UNITED STATES PATENT AND TRADEMARK OFFICE

APPLICATION NO.	FILING DATE	FIRST NAMED INVENTOR	ATTORNEY DOCKET NO.	CONFIRMATION NO.
10/628,431	07/29/2003	Ulrich Wegmann	Q76579	5290
23373	7590	02/15/2006	EXAMINER TURNER, SAMUEL A	
SUGHRUE MION, PLLC 2100 PENNSYLVANIA AVENUE, N.W. SUITE 800 WASHINGTON, DC 20037			ART UNIT 2877	PAPER NUMBER

Office Action Summary

FIG. 1

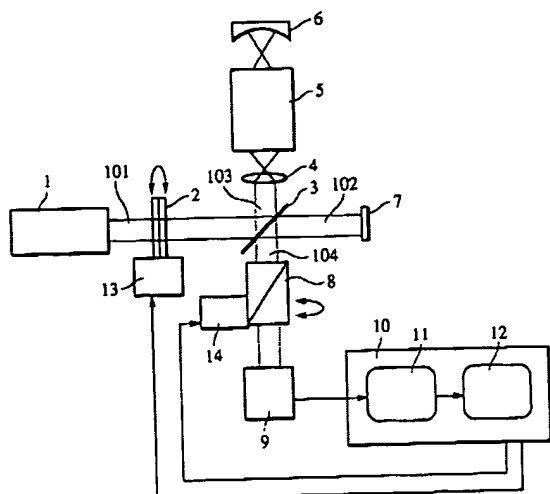
With regard to claim 1, Ouchi teaches a method for determining the influencing of the state of polarization of optical radiation by an optical system under test, in which

entrance-side radiation with a defined entrance state of polarization is directed onto the optical system(1,2, paragraph [0012]),

the exit state of polarization is measured by radiation emerging from the optical system(8,9, paragraph [0012]), and

the influencing of the state of polarization by the optical system is determined by means of evaluating the measured exit state of polarization with reference to the entrance state of polarization(102,103, paragraph [0012]),

wherein the influencing of the state of polarization caused by an optical imaging system of prescribable aperture is determined with pupil resolution(paragraph [0015]).

As to claim 2, wherein the defined entrance state of polarization is provided in an object plane of the imaging system, and the exit state of polarization is measured with pupil resolution within a prescribable pupil range of the imaging system(paragraphs [0012],[0015]).

With regard to claim 8, Ouchi teaches an apparatus for determining the influencing of the state of polarization of optical radiation by an optical system under test, having

means for providing entrance-side radiation, directed onto the optical system, with a defined entrance state of polarization(1,2, paragraph [0012]),

polarization detector means for measuring the exit state of polarization of radiation emerging from the optical system(8,9, paragraph [0012]), and

an evaluation unit for determining the influencing of the state of polarization by the optical system by means of evaluating the measured exit state of polarization with reference to the entrance state of polarization(10, paragraph [0012]),

wherein the polarization detector means are configured to measure the exit state of polarization with pupil resolution, and the evaluation unit is configured to determine the influencing of the state of polarization with pupil resolution.

As to claim 14, wherein the evaluation unit is configured for determining the phase-reduced or complete, pupil-resolved Jones matrix(10, paragraph [0012]).

With regard to 27, Ouchi teaches a test apparatus comprising:
a source of entrance-side radiation, directed onto an optical system, with a defined entrance state of polarization(1,2, paragraph [0012]),
a polarization detector configured to measure the exit state of polarization of radiation emerging from the optical system with pupil resolution(8,9, paragraph [0012]), and
an evaluation unit configured to evaluate the measured exit state of polarization with reference to the entrance state of polarization with pupil resolution(10, paragraph [0012]).

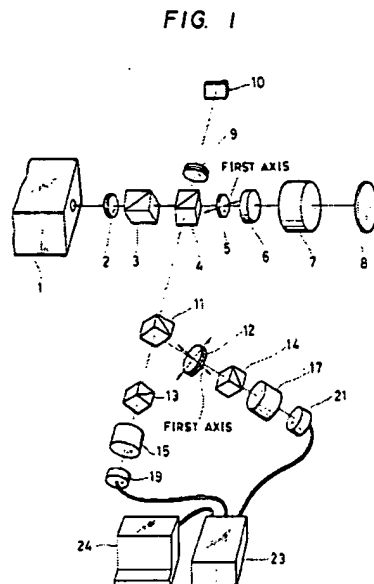
Claims 1-3, 8, 12, 14, and 27 are rejected under 35 U.S.C. 102(b) as being clearly anticipated by Ohuchi(4,798,468).

With regard to claim 1, Ohuchi teaches a method for determining the influencing of the state of polarization of optical radiation by an optical system under test, in which

entrance-side radiation with a defined entrance state of polarization is directed onto the optical system(1-3, column 2, lines 54-61),

the exit state of polarization is measured by radiation emerging from the optical system(19,21, column 4, lines 55-68), and

the influencing of the state of polarization by the optical system is determined by means of evaluating the measured exit state of polarization with reference to the entrance state of polarization(column 3, lines 21-59),

wherein the influencing of the state of polarization caused by an optical imaging system of prescribable aperture is determined with pupil resolution(column 4, lines 55-68).

As to claim 2, wherein the defined entrance state of polarization is provided in an object plane of the imaging system, and the exit state of polarization is measured with pupil resolution within a prescribable pupil range of the imaging system(column 2, lines 54-61; column 4, lines 55-68).

As to claim 3, wherein a spatially incoherent point light radiation emanating from the object plane of the imaging system is provided as entrance-side radiation(1, column 7, line 1).

With regard to claim 8, Ohuchi teaches an apparatus for determining the influencing of the state of polarization of optical radiation by an optical system under test, having

means for providing entrance-side radiation, directed onto the optical system, with a defined entrance state of polarization(1-3, column 2, lines 54-61),

polarization detector means for measuring the exit state of polarization of radiation emerging from the optical system(12-14,19,21; column 4, lines 55-68), and

an evaluation unit for determining the influencing of the state of polarization by the optical system by means of evaluating the measured exit state of polarization with reference to the entrance state of polarization(23,24, column 3, lines 21-59),

wherein the polarization detector means are configured to measure the exit state of polarization with pupil resolution, and the evaluation unit is configured to determine the influencing of the state of polarization with pupil resolution(column 4, lines 55-68).

As to claim 12, wherein the polarization detector means include a CCD detector and upstream second polarization means(column 4, lines 55-68).

As to claim 14, wherein the evaluation unit is configured for determining the phase-reduced or complete, pupil-resolved Jones matrix(23,24, column 3, lines 21-59).

With regard to claim 27, Ohuchi teaches a test apparatus comprising:
a source of entrance-side radiation, directed onto an optical system, with a defined entrance state of polarization(1-3, column 2, lines 54-61),
a polarization detector configured to measure the exit state of polarization of radiation emerging from the optical system with pupil resolution(12-14,19,21; column 4, lines 55-68), and
an evaluation unit configured to evaluate the measured exit state of polarization with reference to the entrance state of polarization with pupil resolution(23,24, column 3, lines 21-59).
